53 TYNE STREET

Original Permit No. 39/1599
Amendment No. 1

AMENDMENT TO APPLICATION FOR PERMIT

Location 53 Tyng Street Ward 6 Within Fire Limits? yes Dist. No. 3

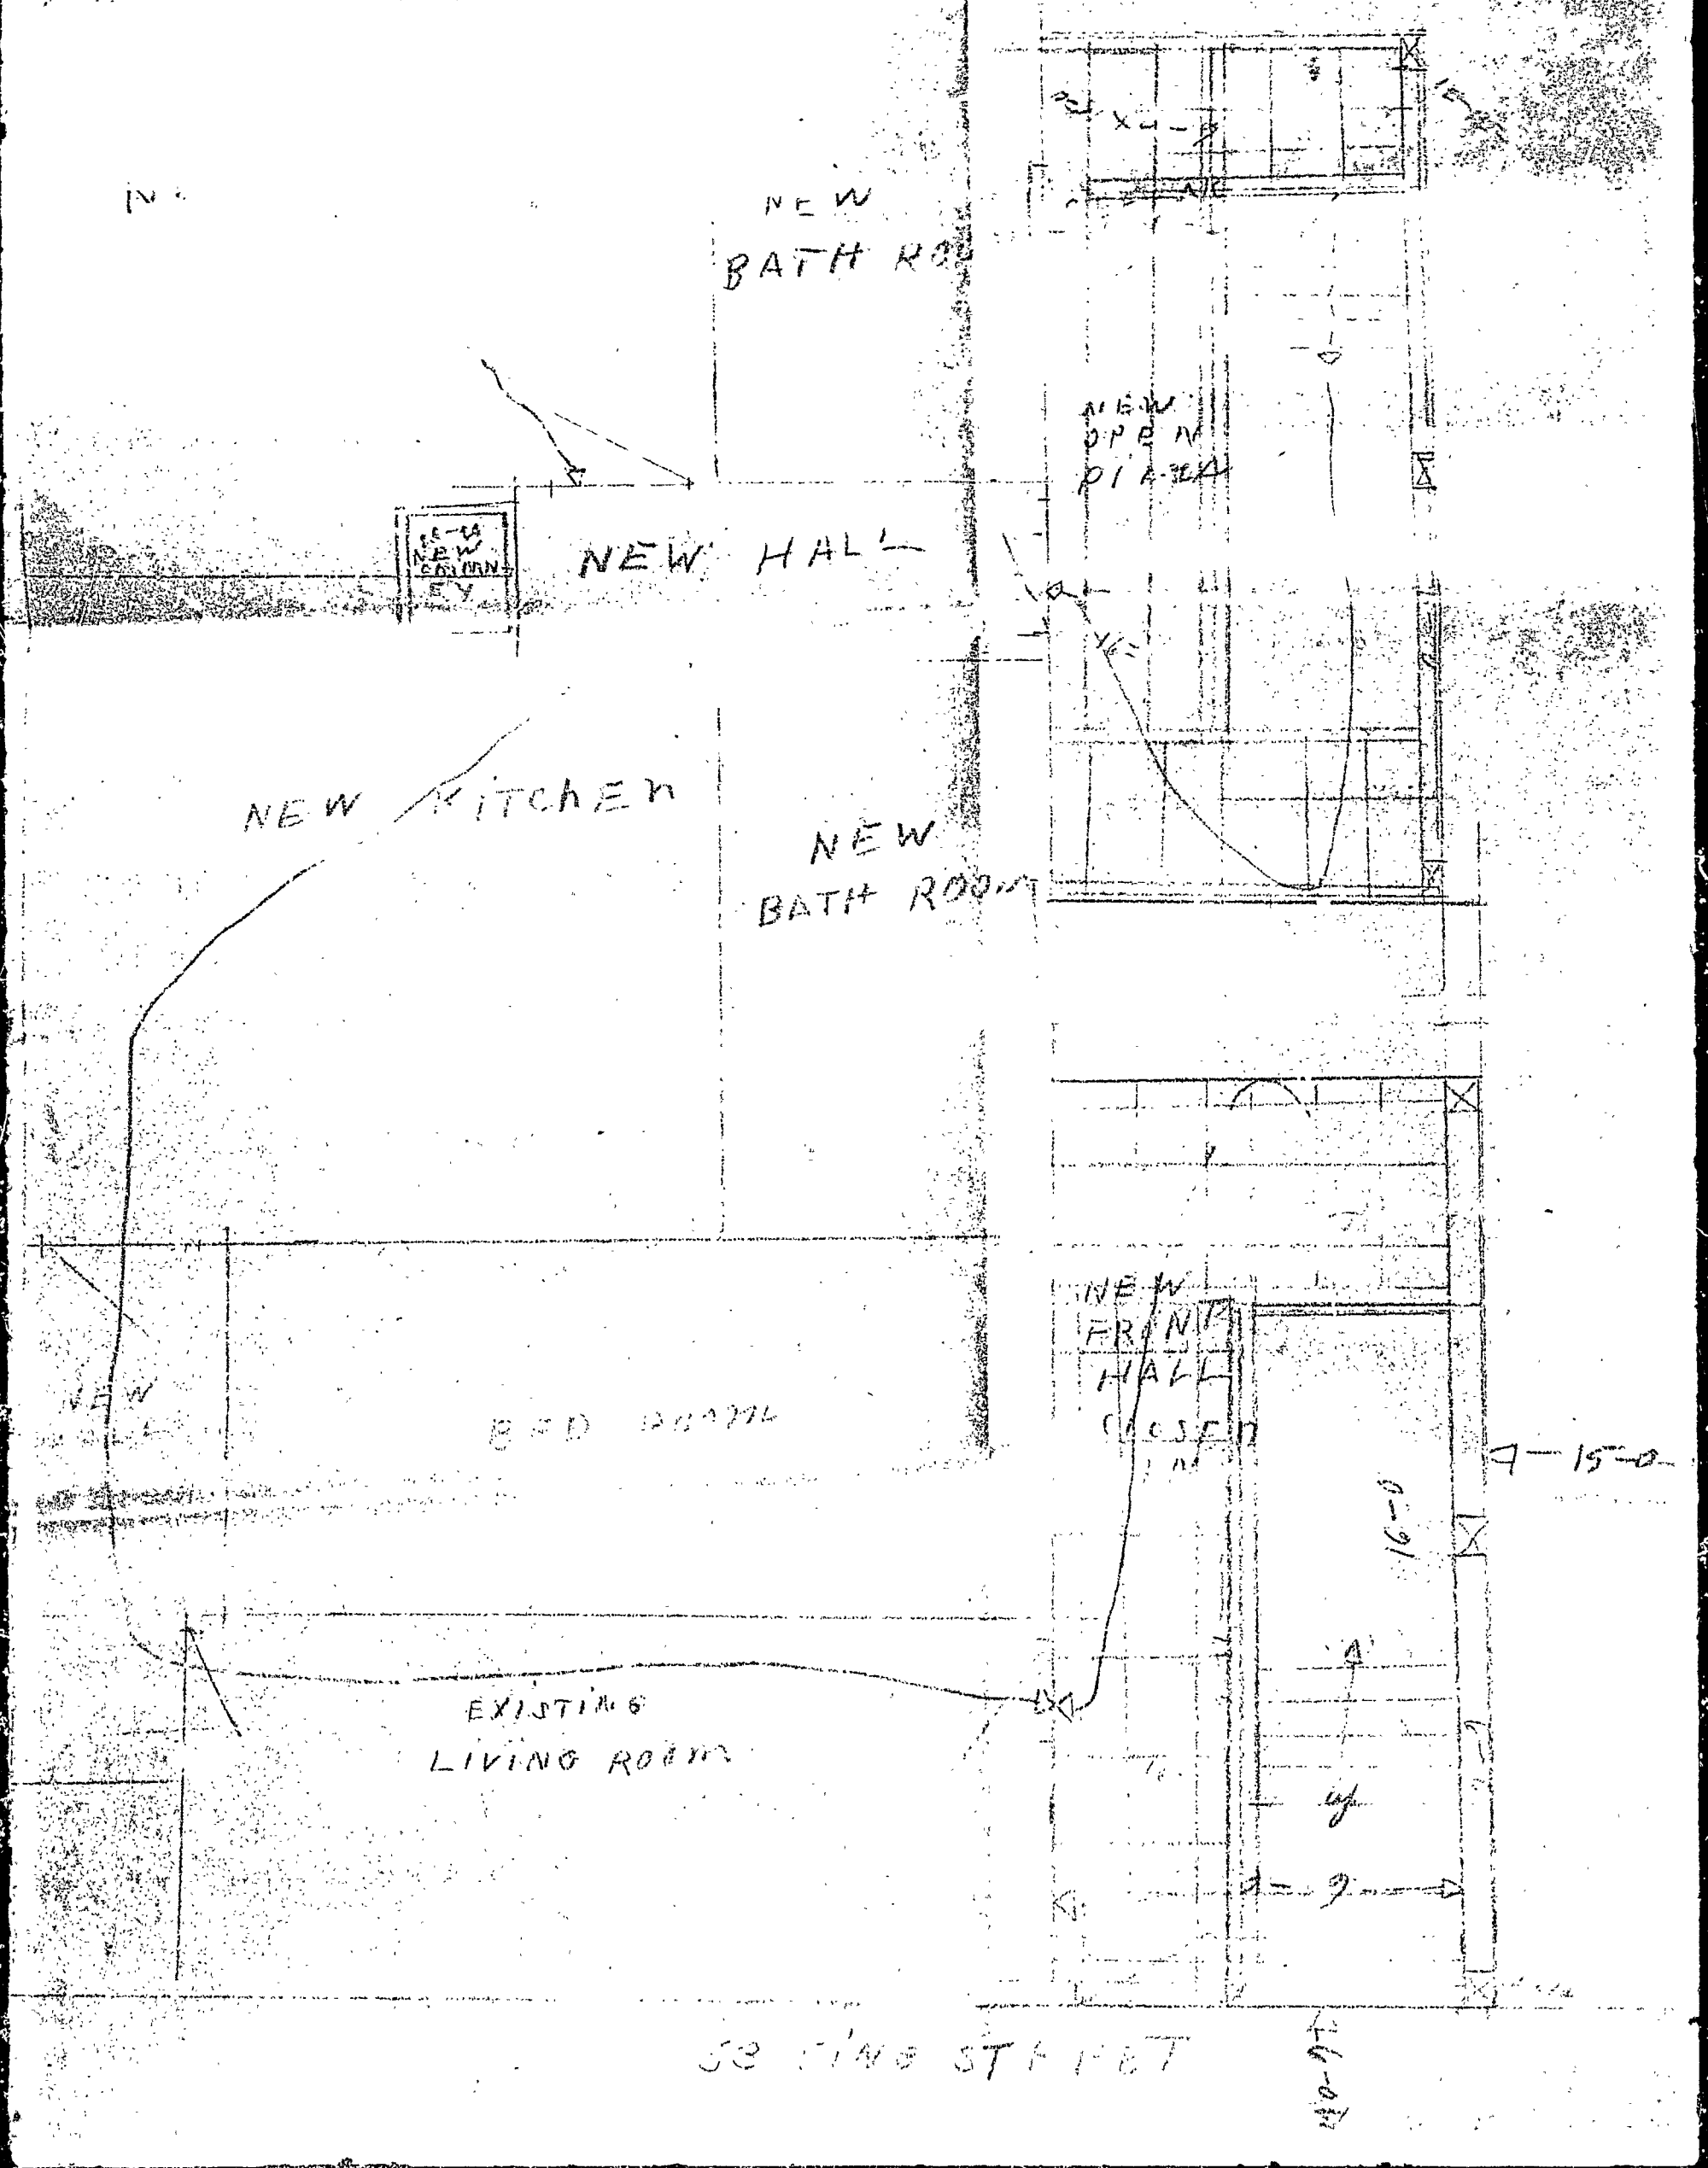
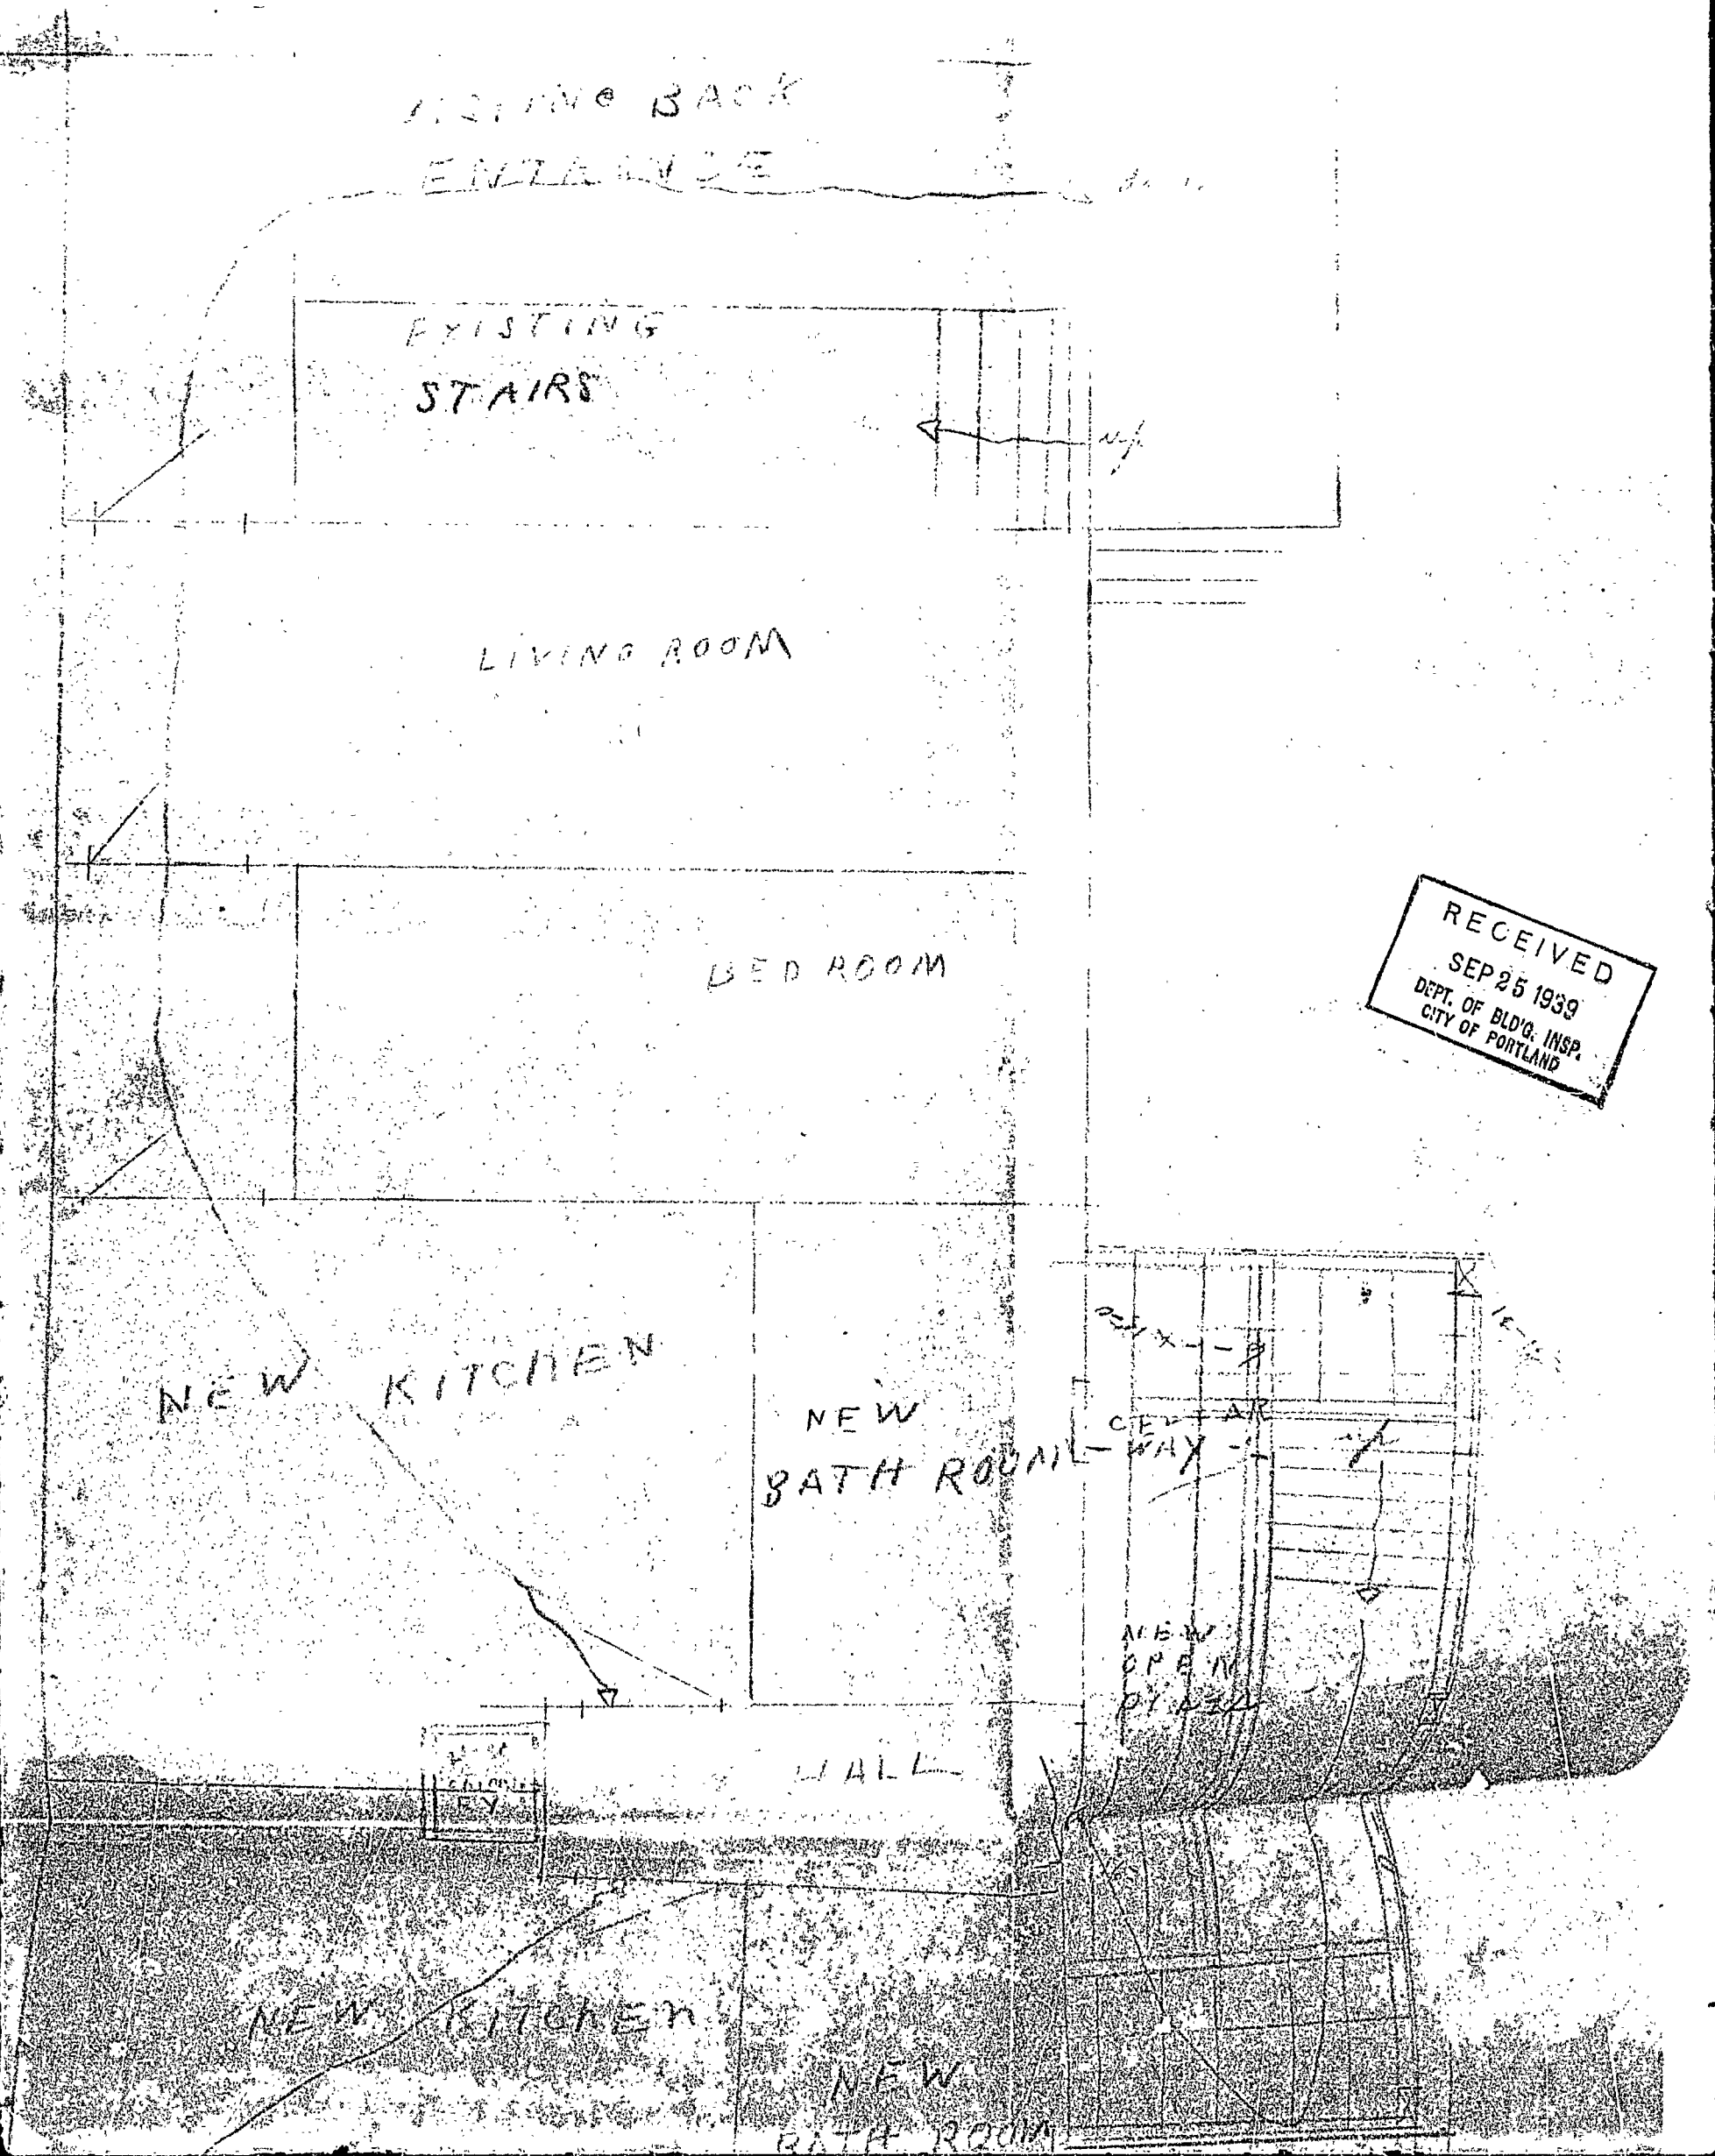
It is practically impossible for us to check thoroughly a plan such as Mr. Kroot has submitted. The plan is not to scale or in proportion. It does not show the sizes of the rooms; it shows only a few of the windows in the outside walls and not any of the doors in the interior partitions. You can see that such a plan gives us no opportunity whatever to check against the light and air requirements of the building code for a tenement house. The law must be complied with nevertheless, and you will have to take all the chances.

The following details come to mind, however, and are called to your attention, although I cannot guarantee that I am covering every item in this letter:

1. The evans of all gas ranges and any gas-fired hot water heaters will have to be vented to masonry chimneys or to vent ducts of tile, wrought or cast iron extending through the roof of the building, no sheet metal connections being permitted outside of the room in which the appliance to be vented is to be located. The size of these ducts is determined by the amount of gas consumption in all of the burners connected thereto for which information the Gas Company should be consulted.

2. The new enclosed stairs are required to be at least three feet wide; the proposed stairs in the open porch are required to be at least 30 inches wide, and neither of these stairs are to have any winders in them. The Code requires that the existing rear stairs be at least two feet ten inches wide and that there shall be not more than three consecutive winders in them. All of the stairs should have a handrail on at least one side. Risers and treads in each set of stairs must be uniform and within the ordinance requirements of minimum treads nine inches and the maximum risers eight and one-half inches. No closets are permitted under any of the stairs in the building.

3. All public halls (I should judge there are only two public halls in the building one on each floor near the middle of the building just inside the open piazza) are required to be at least four feet wide.

4. If there is to be any heating plant, any fire of any description or any hazardous rooms in the cellar, all stairs between the first floor and the cellar are required to be enclosed with fire resistive partitions and with a self-closing fire door at the foot of the stairs. The fire resistive partitions may be 2x3 studs no more than sixteen inches from center to center, running vertically, and covered on both sides with metal lath or specially manufactured perforated gypsum lath, in either case

plastered upon. The fire door would have to be covered completely with tin or galvanized metal with locked joints at each seam and the frame of the door would have to be similarly covered all over so as to effectually exclude air from the wood of the door frame and trim. By the term self-closing is meant a door which is normally closed and kept closed by an approved device such as a door closer.

5. Chemical fire extinguishers of a type bearing the label of approval of the Underwriters' Laboratories, Inc. for the use intended are required one in the cellar and one on each of the first and second floors where the apartments are. The proper location for these fire extinguishers in first and second floors would be in the public halls in the center of the building.

6. Mr. Adams has raised the question about lights in the halls. Since the used floors in the building only include two stories in height, I think the Building Code does not require you to have lights on the owner's meter in the halls. I suggest, however, that you provide electric lights on both floors in the extreme rear stairhall for the rear second story tenant to be controlled by a single switch and that you provide similarly for the front second story tenant in the front stair-halls.

7. I am told that you are taking every precaution and reasonable means of permanently strengthening the first floor, and will do so in the second floor framing wherever found necessary as indicated in my letter to you of August 24, 1939. I note that you propose a new chimney and I presume the other chimneys in the building are to be removed. If not, it will be necessary to extend them down and provide cast iron cleanout doors and frames at the bottom of the flues as indicated in my letter of August 24th. If the existing chimney flues, however, are to be used only for gas appliance vents, no probable shall not require that they be extended down or equipped with cleanouts.

8. The framing of the enclosed and open porches appears to be generally satisfactory, but I presume the 4x8 studs will be set with the eight inches dimension upright, that doubled joists will be used around all sides of stairwells, and I can discover no sign of timbers intended to support the outer ends of the second floor of the open piazza or the outer ends of the rafters of the roof of the open piazza.
